SERVICE BULLETIN

NO. A361-71-2

Conversion Procedure To Convert Norco Inc. Strut Assembly A361-5 To A361-9

FIGURE 1

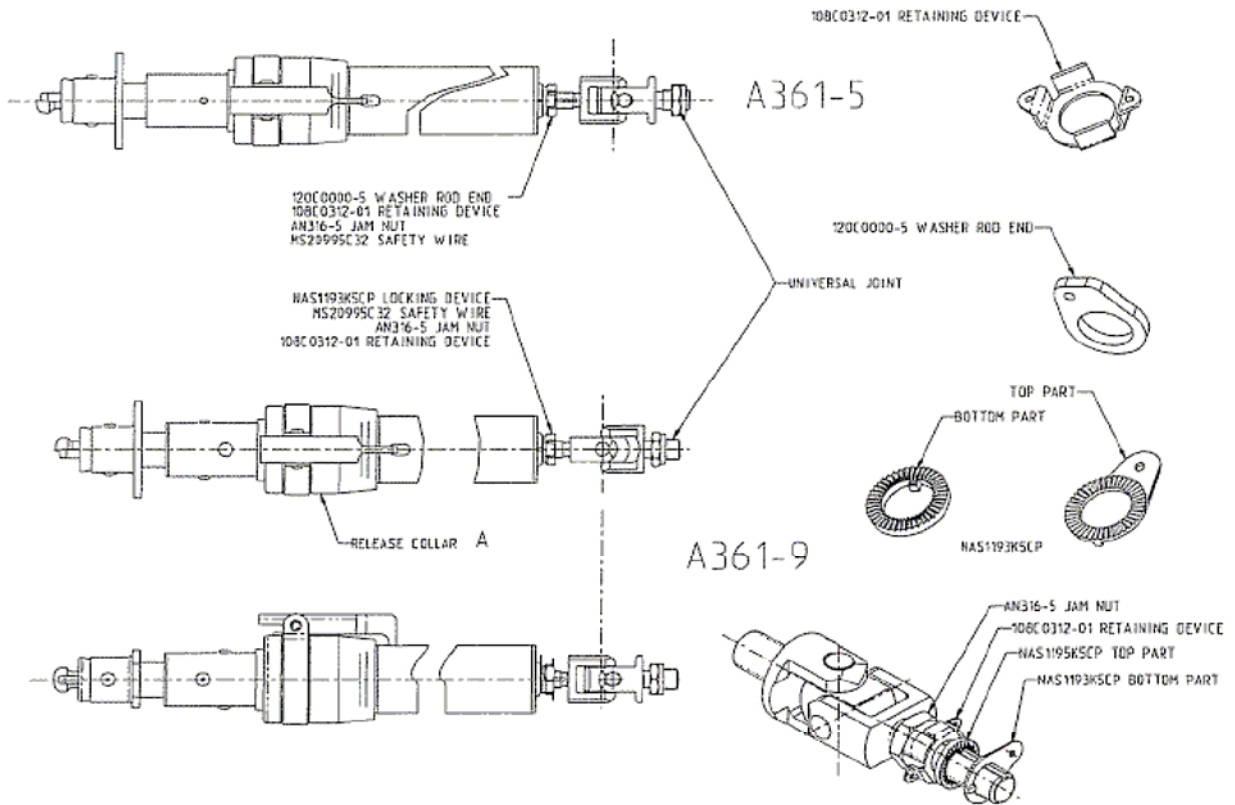
This Service Bulletin is to inform all users of the procedures and detailed instructions required for reworking Norco part number A361-5. The reworking requires reorientation of the universal assembly on the A361-5 to the orientation required on A361-9.

- (1) Cut safety wire MS20995C32 and discard.
- (2) Using a .500 open-end wrench, loosen jam nut AN316-5 approximately 4 turns by rotating counterclockwise.
- (3) Slide retaining device 108C0312-01 back with jam nut AN316-5.
- (4) Slide washer rod end 120C0000-5 back out of slot in strut end fitting.
- (5) Remove universal from strut assembly by rotating counterclockwise.
- (6) Discard washer rod end 120C0000-5 and retaining device 108C0312-01.

- (1) Washer rod end 120C0000-5 is to be replaced with NAS1193K5CP locking device.
- (2) Replace jam nut AN316-5 and new retaining device 108C0312-01 on threaded shaft of universal.
- (3) Install bottom part of NAS1193K5CP so that internal key engages key slot in universal shaft with the serrations facing the end of the threaded shaft.
- (4) Position top part of NAS1193K5CP so that serrations are engaged with serrations on bottom part.
- (5) Engage threaded shaft of universal in threaded bore of strut end fitting.

- (6) Thread universal into strut end fitting by rotating clockwise.
- (7) Continue rotating until extended and locked length of $43.00 \pm .06$ is obtained.
- (8) Adjust position of universal joint as shown on figure 1.
- (9) Engage key on top part of NAS1193K5CP with slot in strut end fitting
- (10) Engage serrations of bottom part with top part.
- (11) Rotate jam nut AN316-5 and retaining device 108C0312-01 together clockwise until contact with NAS1193K5CP is made.
- (12) Torque jam nut AN316C5 to 30/50 lb.-in.
- (13) Install new safety wire MS20995C32 in accordance with MS33540.
